TRANSAXLE—AX4S/AX4N—REDESIGNED PARK SYSTEM—SERVICE TIP	Article No. 99-20-2

FORD: 1999-2000 TAURUS, WINDSTAR

ISSUE

1999 Taurus, Sable and Windstar vehicles with an AX4S transaxle built August 1999 and beyond and all 2000 Taurus, Sable and Windstar vehicles with AX4S or AX4N transaxles and 2000 Continental vehicles built October 1999 and beyond have a new redesigned park system in the transaxle. The parts are NOT interchangeable with the original design.

Figure 1 - Article 99-20-2

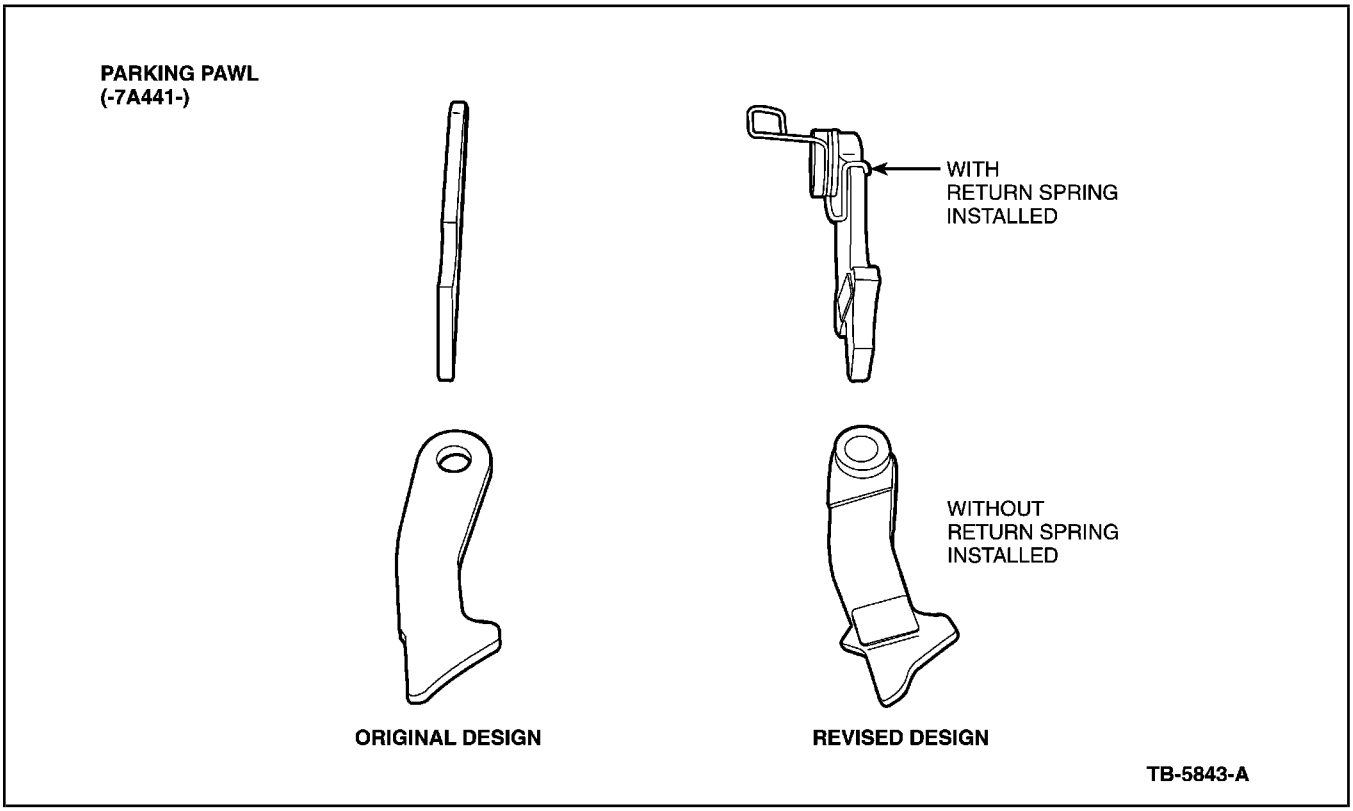
- Parking Pawl (-7A441-), Figure 1
- Parking Pawl Return Spring (-7D070-), Figure 2
- Parking Pawl Shaft (-7D071-), Figure 3
- Parking Pawl Shaft Retention Bolt (new item, AX4S only), Figure 4
- Abutment Plate (-7G101-), Figure 5
- Parking Pawl Apply Rod (-7D410-), Figure 6
- Apply Rod Inner Lever (-7A256-), Figure 7
- Detent Lever (-7A115-), Figure 8
- Detent Spring (-7E332-), Figure 9
- Manual Control Shaft (-7C493-), Figure 10
- Transaxle Case (-7005-), Figure 11
- Chain Cover (-7G188-), Figure 12
- Chain Cover Gasket (-7G303-), Figure 13
- Rear Planetary Support (-7A130-, AX4S only), Figure 14
- Lower Pan (-7A194-, AX4N only), Figure 15
- Combined Rear Lube and Differential Lube Tube (-7G084-, AX4N only), Figure 16
- Pinion Shaft in Differential Case Retaining Ring, Figure 17

Figure 14 - Article 99-20-2

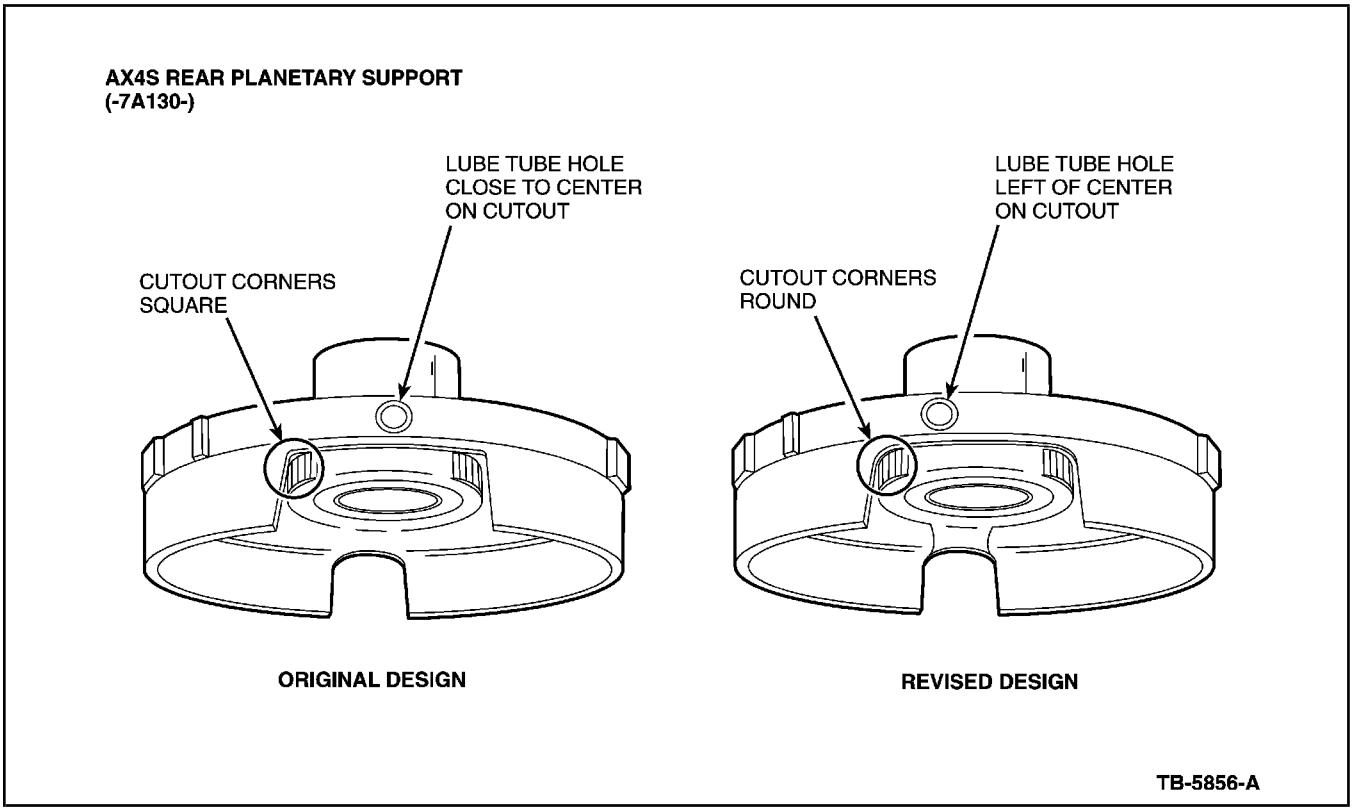
1. The roll pin locations on the manual shaft have changed and the levers on the manual shaft face the opposite direction.
2. The collar that the roll pin goes through on the two levers face inward on the new design, Figure 18.
3. The parking pawl, parking pawl return spring and the abutment plate are larger and differ in shape from the original design, Figure 19.
4. One part that may be more difficult to identify would be the Rear Planetary Support (-7A130-) on the AX4S transaxle only, refer to Figure 14.
